GNRO-2010/00073

SUBJECT: Supplemental Information
License Amendment Request, Extended Power Uprate
Grand Gulf Nuclear Station, Unit 1
Docket No. 50-416
License No. NPF-29

Supplemental Information

Figure 1: GGNS Blackness Test Boraflex Panel Gap Loss Data

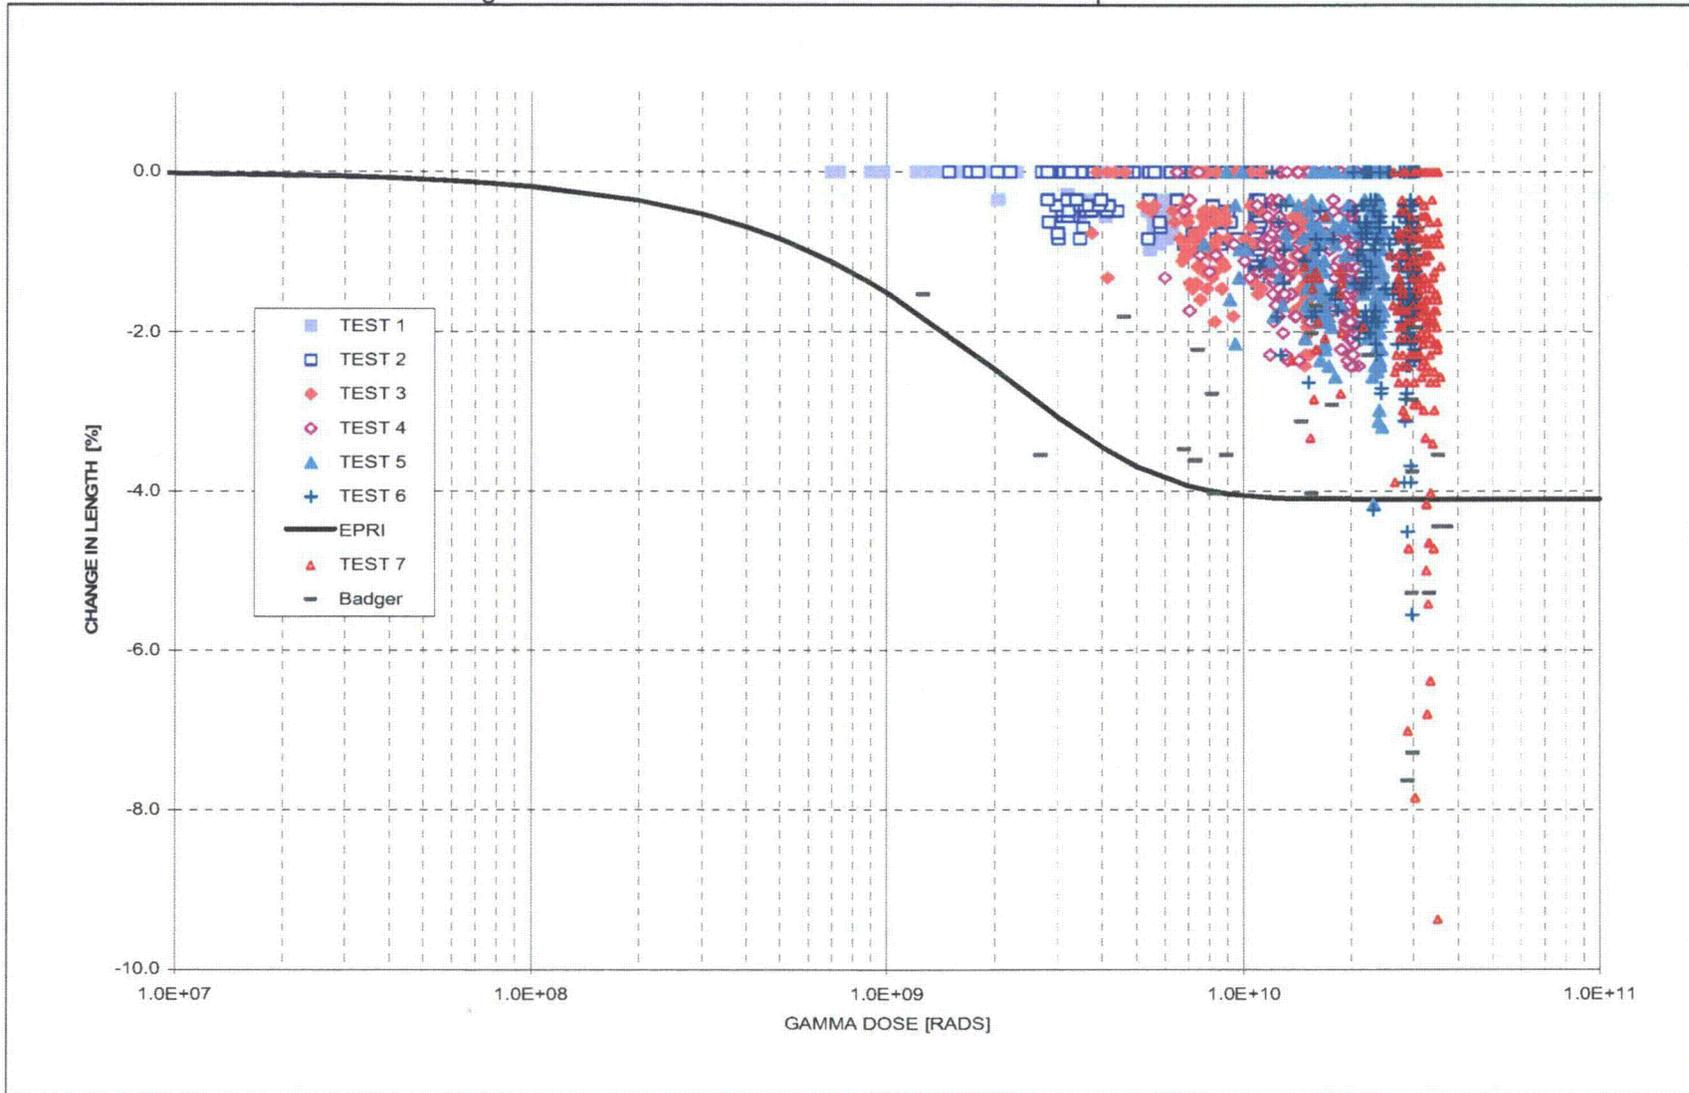
4. In Sections 2.8.6.1, "New Fuel Storage," and 2.8.6.2, "Spent Fuel Storage," of its submittal, the licensee cites NEDC-33004P-A as the basis for demonstrating compliance with 10 CFR Appendix A General Design Criterion 62, "Prevention of criticality in fuel storage and handling." However, NEDC-33004P-A, Section 6.3.4 addresses the increased decay heat load associated with a constant pressure power uprate and does not address criticality. Therefore, there is no information in the licensee's submittal that addresses criticality in fuel storage and handling and the NRC staff has insufficient information to begin its review. The NRC staff requests the licensee provide the nuclear criticality safety analysis that demonstrates compliance with GDC 62.

The results of this process, which has been repeated for seven test campaigns, are illustrated in Figure 1. The total panel gap as a percent of the initial panel length vs. dose follows the EPRI Boraflex shrinkage model until the dose exceeds $2.3E10$ rads. The loss accelerates as the panels approach $3.0E10$ rads. This performance is consistent with gap edge erosion that occurs as flow increases in the presence of larger gaps.

Table 1 provides the results of Blackness and Badger tests with total panel losses that exceed the 4.1% EPRI shrinkage model. The average dose for these panels is $3.24E10$ rads. A dose level of $2.3E10$ rads was selected to demark the transition in the Boraflex performance since, as observed from Figure 1, the transition to higher panel losses occurs at a significantly higher dose level (around $3.0E10$ rads). Additionally, all panel losses greater than the 4.1% EPRI shrinkage model result occur above this dose value ($2.3E10$ rads).

The difference in Boraflex performance is addressed in the criticality analysis by considering two regions of the pool storage configuration (*i.e.*, Regions I and II) and performing a separate analysis of each region. Region I locations continue to credit Boraflex. As shown in Figure 1, blackness tests 1-6 are consistent with expected panel losses from Boraflex shrinkage. For conservatism, the results from test 7 were selected for use in the criticality analysis. Additionally, the criticality analysis input assumptions were selected to provide additional conservatism to the measurements. Figure 2 shows the probability distribution for the number of gaps a given panel may contain. The analysis does not credit the zero gap probability. Additionally, the analysis inputs are biased toward 1 and 2 gaps. This will result in conservatively larger gaps sizes and therefore higher reactivity configurations. Figures 3 and 4 illustrate the total panel losses, from gaps, and the individual gap size distribution. The analysis inputs are biased toward larger gaps for both distributions. Figure 5 shows the axial gap location distribution. The analysis assumption forces all of the gaps into the center 6 feet of the panel which maximizes the reactivity impact. The central 12 inches have a probability assumption greater than any observed value. In net, the Boraflex gap distributions used in the criticality analysis are significantly conservative relative to the GGNS measurements and the measurements are conservative relative to the definition of Region I of the racks.
